COMMENT RESPONSE FOR CONTRACTOR QUERIES
CONSTRUCTION OF DUBAIR ROAD (PACKAGE-1)

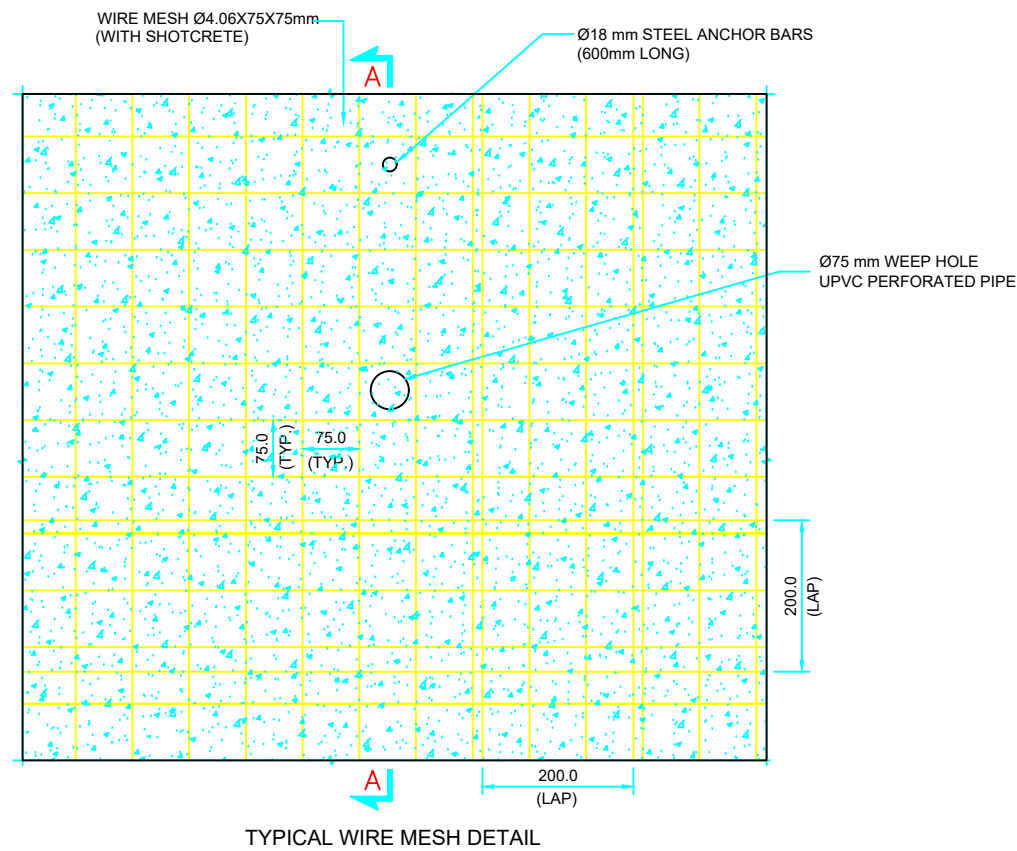
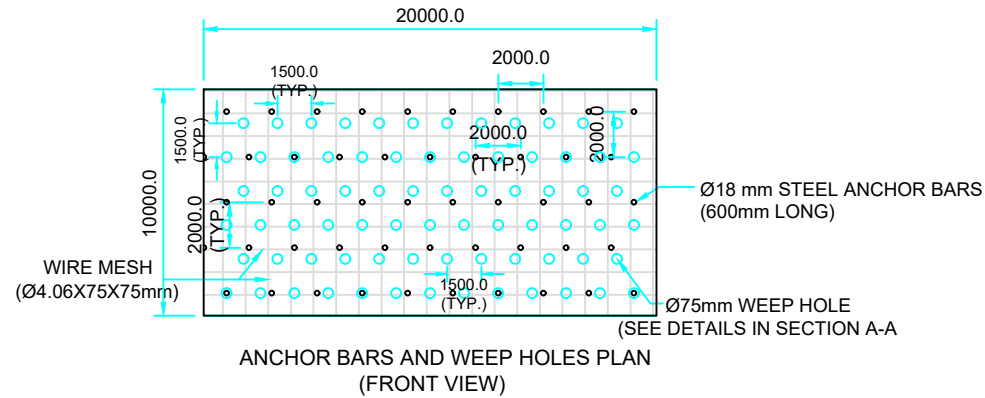
6	Bill No. 5 – Rock Bolt & Shotcrete: Please provide the detailed design/drawings and technical specifications for the rock bolt and shotcrete works, including bolt spacing, anchorage/grouting requirements, reinforcement/mesh details, and applicable concrete/shotcrete grade.	The rock bolting shall be carried out compliant to the specifications / provisions of MRS-KP-2025 (1st-Biannual) Item No. 16-52-d (p-212). The specific drawings shall be provided at the Construction Drawings. Shotcrete drawing is attached herewith.
7	Bill No. 4 – Pile Load Test: As per Bill No. 4, Item No. 03, the quantity of pile load tests is 3 Nos., whereas the total number of piles is only 12 Nos. Considering the limited number of piles, we propose that one pile load test may be sufficient. Please clarify the required number and type of pile load tests.	Pile load test for each bridge location has been proposed as detailed geotechnical investigations have not been conducted at design stage. However, during construction stage if geotechnical expert proposes to omit or combine pile load test for bridges in close vicinity of 1 to 1.5 km then number of full-scale pile load test can be reduced to finalize the length of pile of each bridge.

- ANCHOR BAR:**
1. THE LENGTH OF THE ANCHOR BAR IS 0.6 m WITH Ø18 mm.
 2. DRILL HOLE WILL BE Ø 37.5 mm & HOLES SHALL BE CLEANED THOROUGHLY PRIOR TO ANCHOR BAR INSTALLATION AND ANCHOR SPACING Will Be 2mx2m(STAGGERED).

3. WEEP HOLES OF Ø75mm WITH UPVC PERFORATED PIPE(LONGITUDINAL SLOT SHALL BE PROVIDED @ 3 m C/C ON FULL FACE HEIGHT OF SLOPE.
 4. THE NUMBER, LOCATION, LENGTH, SPACING, INCLINATION AND ORIENTATION OF ANCHOR BARS AND WEEP HOLES MAY VARY DEPENDING ON ACTUAL GEOLOGICAL CONDITIONS ENCOUNTERED, OR AS DIRECTED BY THE ENGINEER.

5. HOLE DIAMETER & BOLT/ANCHOR DIAMETER MAY VARY ACCORDING TO MANUFACTURERS RECOMMENDATIONS ON THE SPECIFIC BAR & GROUT USED FOR CONSTRUCTION.
- SHOTCRETE AND WIRE MESH**

6. AFTER COMPLETION OF EXCAVATION OF CUT SLOPES IN SOIL/BEDROCK SHOULD BE PHYSICALLY EXAMINED BY A COMPETENT ENGINEERING GEOLOGIST TO ASSESS THE REQUIREMENT OF SHOTCRETE.

7. ENSURE THAT THE SURFACE AREA IS PROPERLY CLEANED AND PREPARED TO RECEIVE THE WIRE MESH AND SHOTCRETE. ANY LOOSE MATERIAL OR CONTAMINANTS SHOULD BE REMOVED.

8. 75-100 mm THICK SHOTCRETE WITH WIRE MESH WILL BE APPLIED.
 9. WIRE MESH WILL BE Ø 4.06 mm WITH 75X75 mm SPACING.
 10. ALL NUTS, PLATES, COUPLES ETC. SHALL BE FULLY COMPATIBLE WITH THE ANCHOR BAR IN TERMS OF GEOMETRIC CONFIGURATION, STRENGTH AND CORROSION RESISTANCE.

11. CLEANING OF THE SLOPE EITHER COMPRESSED AIR OR BY WATER JET PRIOR TO THE APPLICATION OF THE SHOTCRETE.
 12. ALL DIMENSIONS IN MM UNLESS OTHERWISE NOTED.
